CRGref: 07359a Ferngrove Stage 3C 15\_10\_15

**RE: Proposed Acoustical Barrier Section (Lot 148 to 152), Stage 3C, Ferngrove Estate, Ballina**

**Sketch 1:** Acoustic barrier alignment including the recommended barrier extension past Lot 152.

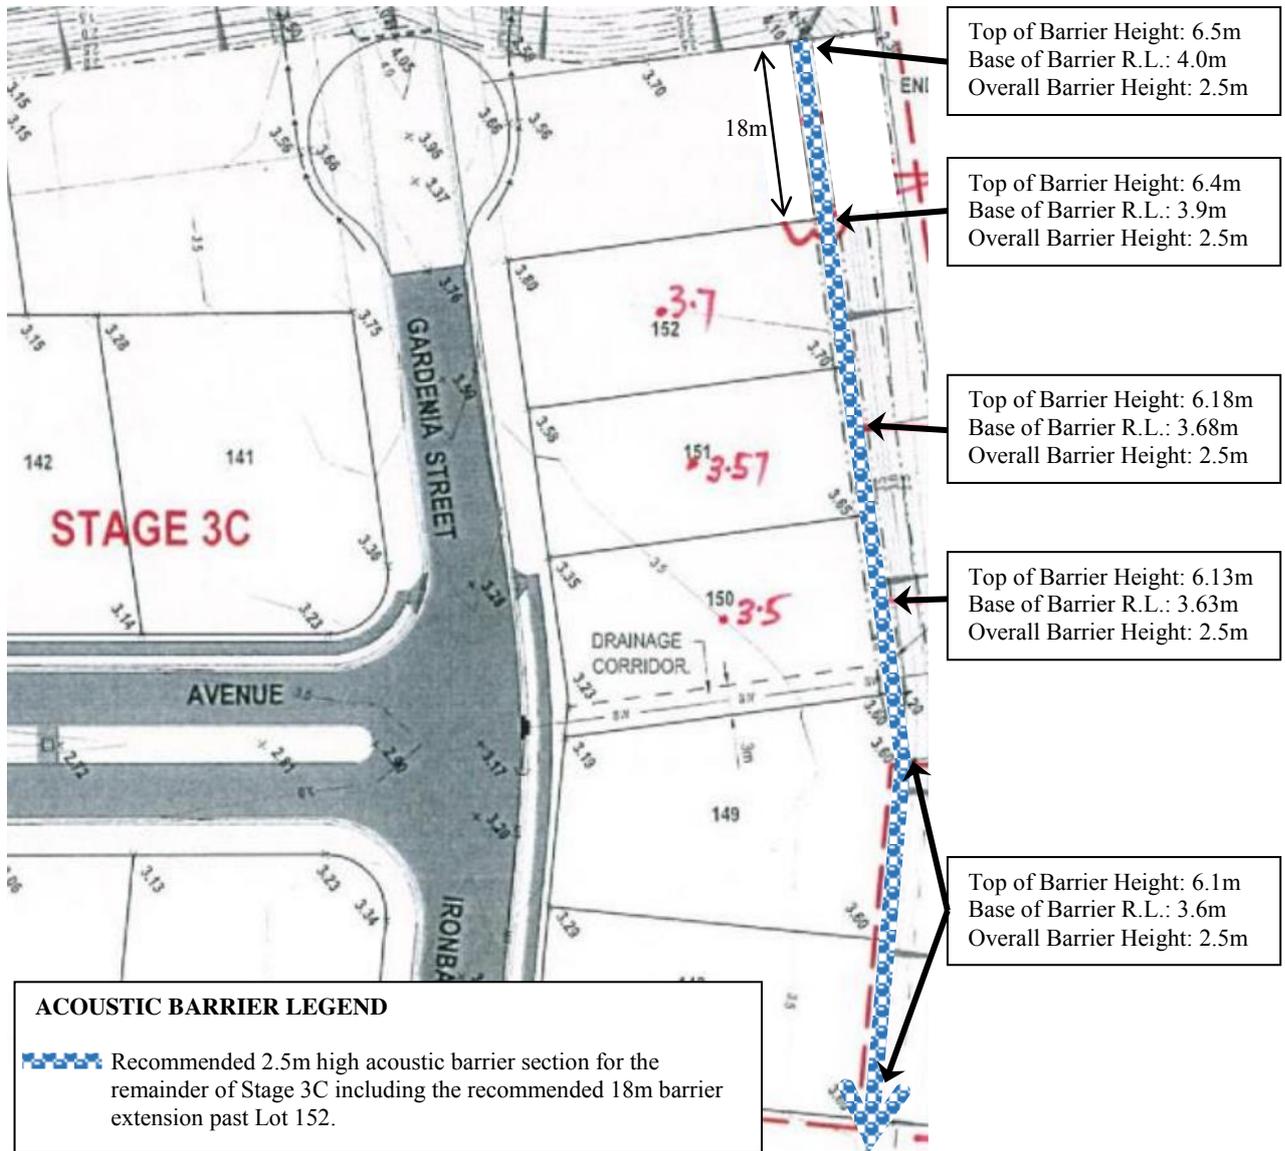
Guidance is also sought for the minimum length of acoustic barrier overrun / extension required past Lot 152 to ensure traffic noise impacts at Lot 152 are of an acceptable level. Based upon our 3D road traffic noise modelling, the acoustical barrier would need to extend 18m past the end of Lot 152 (as detailed in Sketch 1 over the page), which is effectively the length of the future residential lot directly adjacent to Lot 152.

Assuming that the barrier is altered and constructed as per the attached marked-up “*Earthworks Plan Stage 3C*”, including the construction of the 18m barrier extension past Lot 152 (as per Sketch 1 above), we can confirm that the Lots that form Stage 3C will be exposed to traffic noise levels from Tamarind Drive (the old Pacific Highway) deemed acceptable in the approved noise impact assessment.
